LINOTYPE IMPROVEMENT INFORMATION SHEET

NO. 264

KEYBOARD CAM RUBBER ROLL SHAFT BRACKETS, PROVIDED WITH OILITE BEARINGS

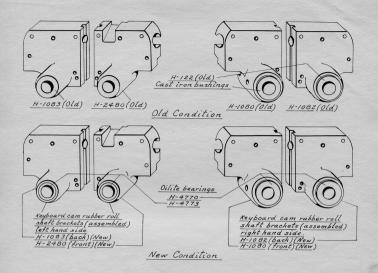
Oilite bearings have been applied to the keyboard cam rubber roll shaft brackets for both right and left hand ends of the rubber roll shafts. This will eliminate the necessity of oiling and prevent the possibility of oil creeping onto the rubber roll and cause deterioration.

Can be applied to outstanding models (excepting high base machines) by substituting new brackets H-1083, H-2480 to left hand side and two oilite bearings H-4770 for brackets on right hand side of kevboari.
